LAKE LACONIA ESTATES

Clinton, Connecticut

REPORT

ENVIRONMENTAL REVIEW TEAM REPORT
ON
LAKE LACONIA ESTATES
CLINTON, CONNECTICUT

TOPOGRAPHY

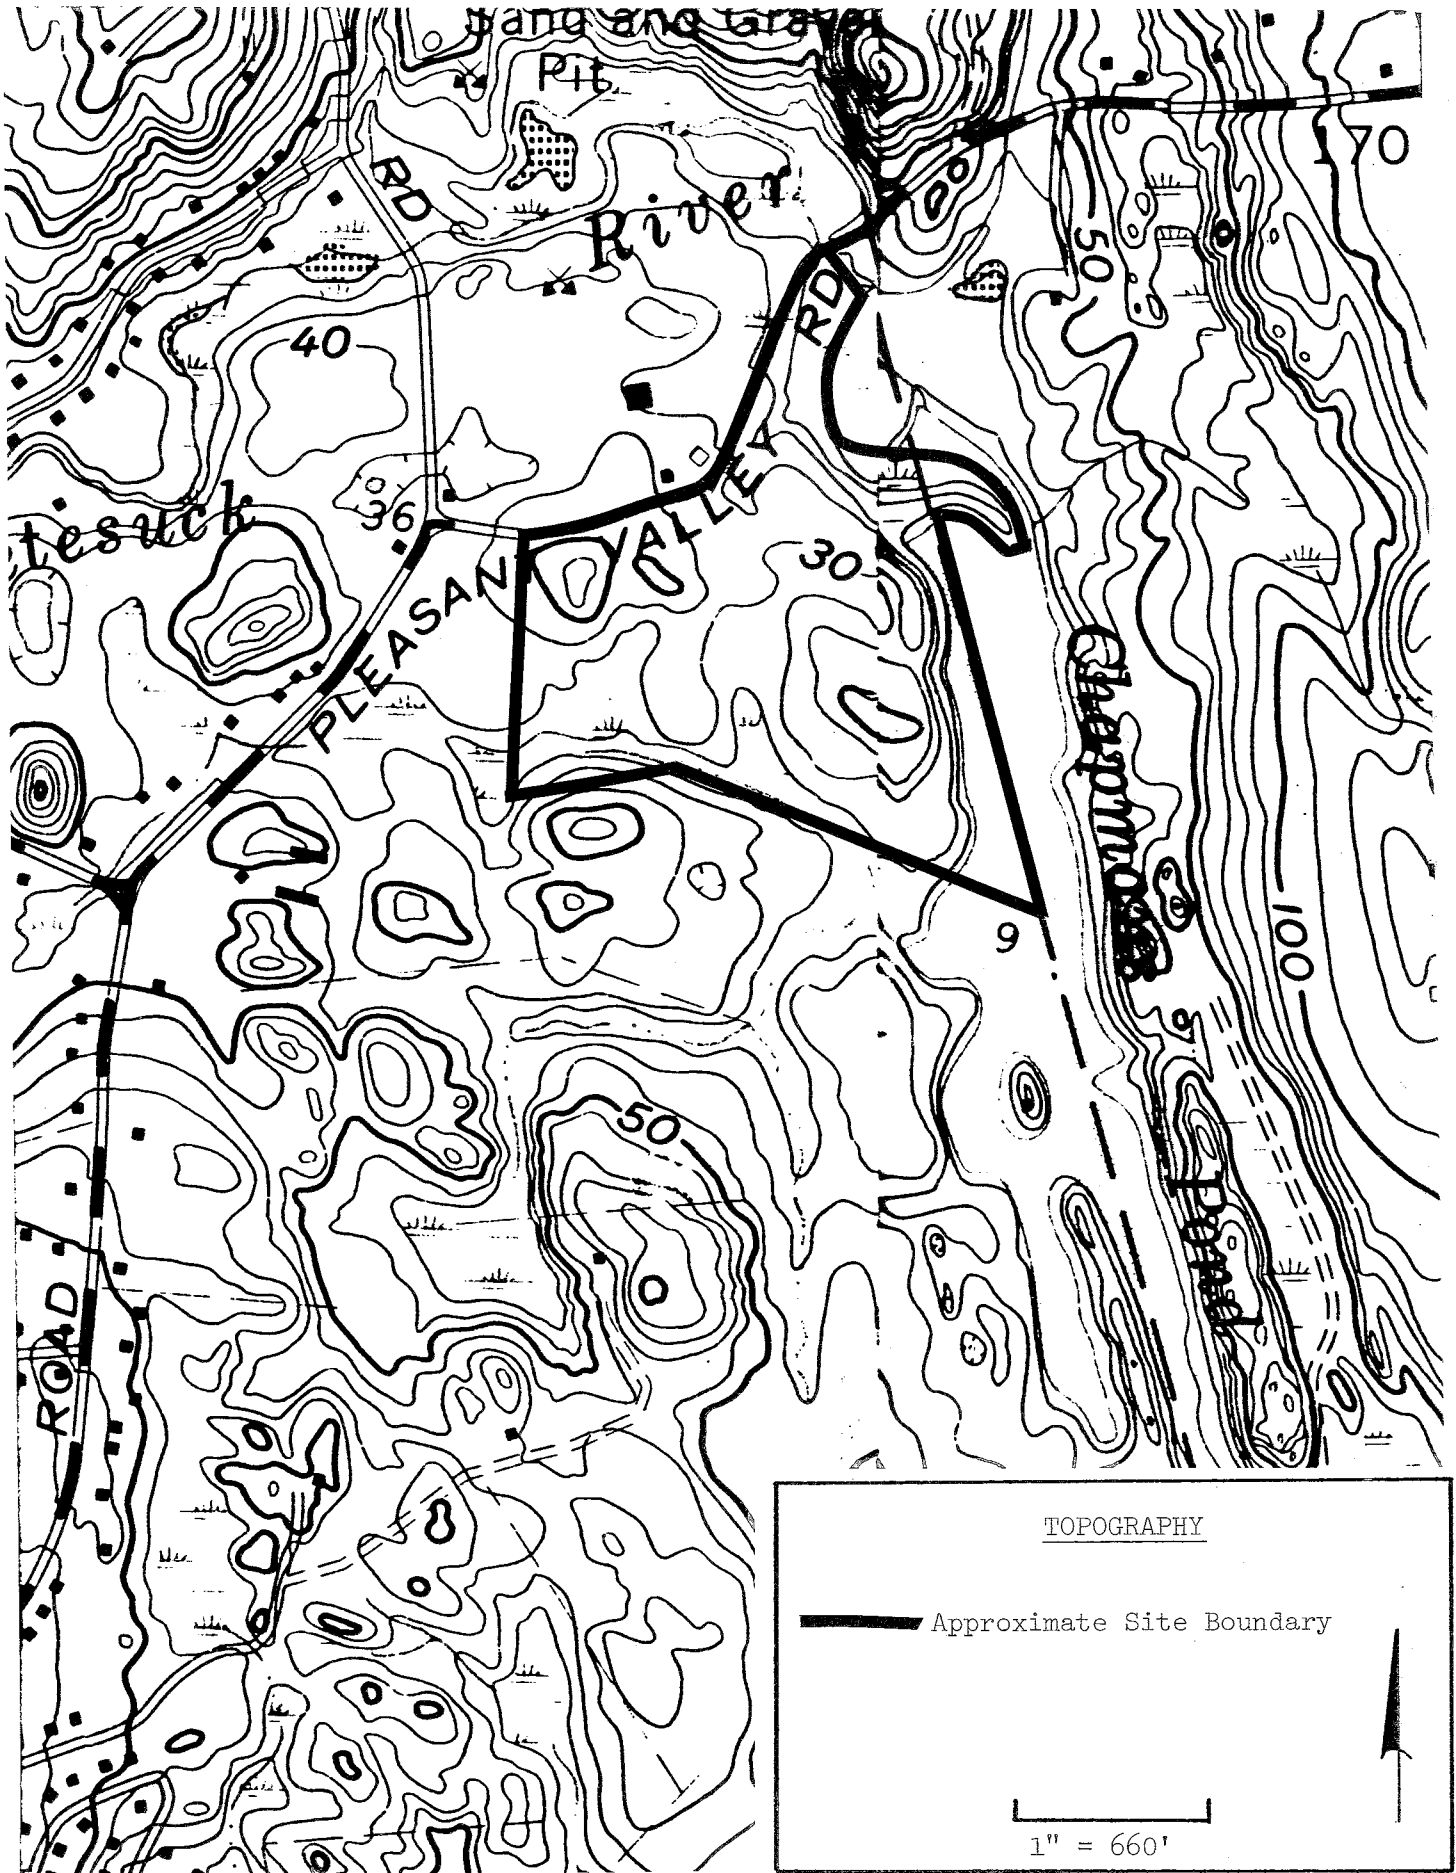
The proposed subdivision site is located at the eastern limits of Clinton. The eastern property boundary marks the Clinton/Westbrook town line. Chapman's Pond, a ±40 acre surface water body and a Menunketesuck River impoundment, lies east of the site. The site consists of about 50 acres of wooded land, on which 16 building lots are presently proposed. It is located in a R-80 zone, which requires minimum building lots to be 80,000 square feet or about 2 acres in size. Present plans indicate lots will range in size from 1.84 acres to 3.79 acres. It is understood that all building lots will be served by individual on-site wells and septic systems. Access to the site is off Pleasant Valley Road. The main road into the site is Laconia Drive, which will be terminated between lots 4 and 5 as a cul-de-sac. Another spur, called Fernwood Lane is proposed off of Laconia Drive. It will terminate between lots 8 and 9 also as a cul-de-sac.

The site consists of an area of hummocky and irregular terrain. Except for the rocky knolls (ledge areas) on the site, land surface throughout most of the site is controlled by the unconsolidated materials (sand and gravel) that overlie tap bedrock surface. Site elevations range from about 10 feet above mean sea level at the eastern limits to 60 feet above mean sea level on top of the rocky knolls on the site. The majority of slopes range from flat to gentle. Areas of very steep slopes are concentrated along the eastern limits near the Menunketesuck River.

Bedrock exposures were observed in the southern part. This area has been delineated on the subdivision plan. Bisecting the central parts of the site in north/south direction are a series of low-lying topographic depressions. These conical shaped depressions are probably sites where large ice blocks detached from glacier ice during retreating periods stood and melted, leaving a void and conical depression in the final landscape. The term "kettle" or "kettle hole" is used for these depressions. (see GEOLOGY section)

Areas Regarded As Having
A High Potential For
Prehistoric Occupation

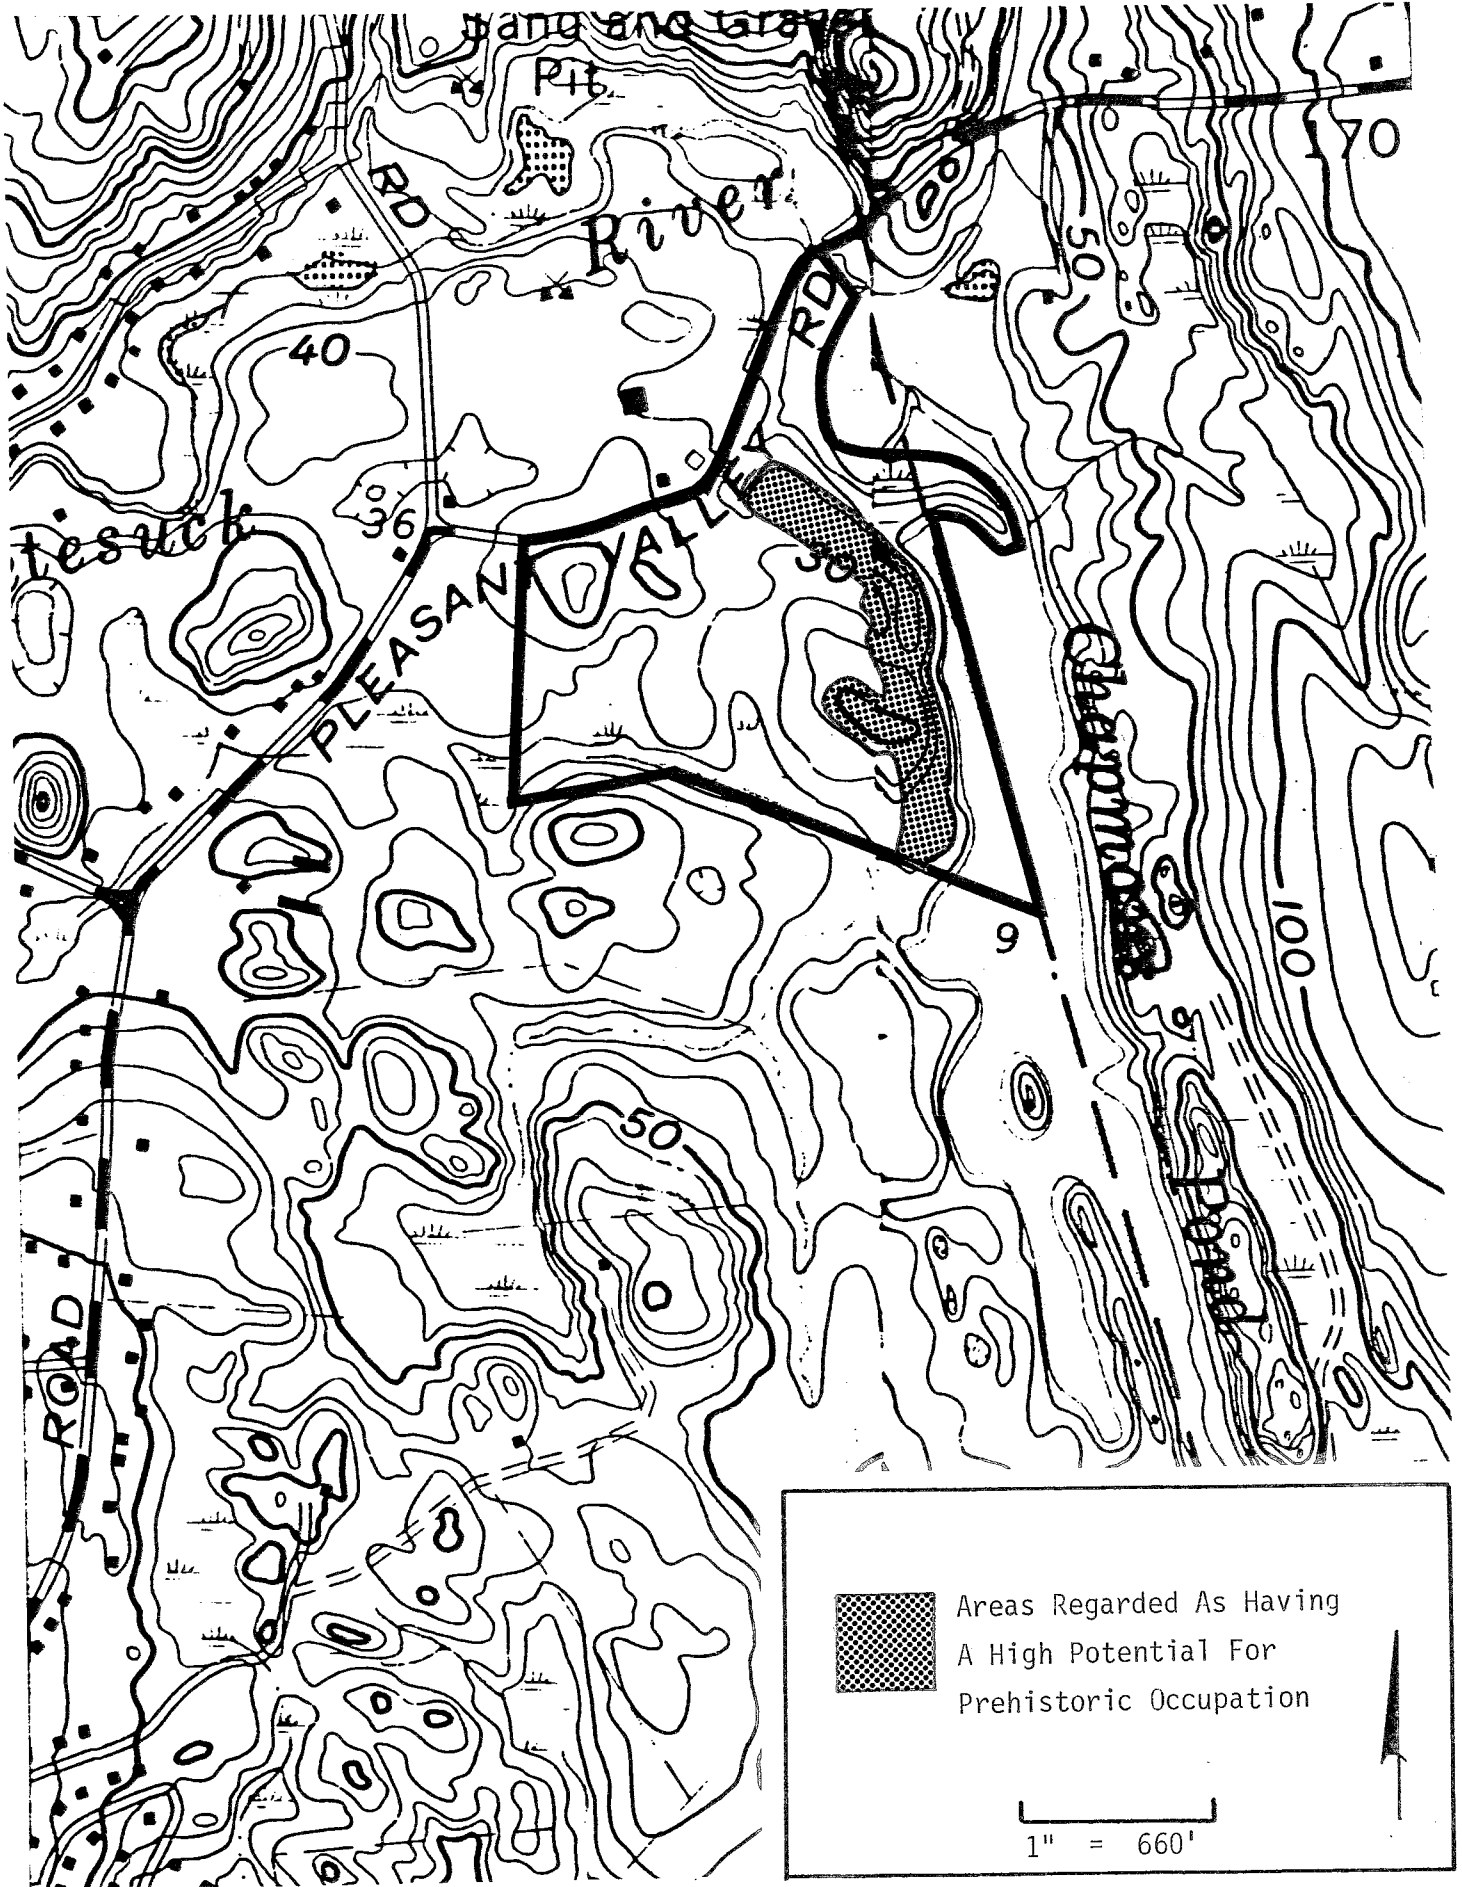
On-site inspection located no cultural materials within areas where the immediate topsoil had been disturbed. However, this survey method is extremely limited and subsurface testing may very well reveal evidence of prehistoric occupations. The proposed development project would adversely impact such cultural resources. Based on predictive models of archaeological site surveys conducted in Connecticut, the impact area is regarded as having a high potential for prehistoric occupation, especially along the knolls adjacent to and immediately above the wetlands. A professional archaeological reconnaissance survey is strongly recommended in order to locate and identify all prehistoric archaeological resources which might exist in the project area. All archaeological studies should be undertaken in accordance with the Connecticut Historical Commission's Environmental Review Primer for Connecticut's Archaeological Resources.

In summary, the project area is located in a critical area of importance to prehistoric hunting and gathering economic societies. It is strongly recommended that all feasible efforts be undertaken to identify and ensure the preservation and conservation of the prehistoric cultural resources in the area.
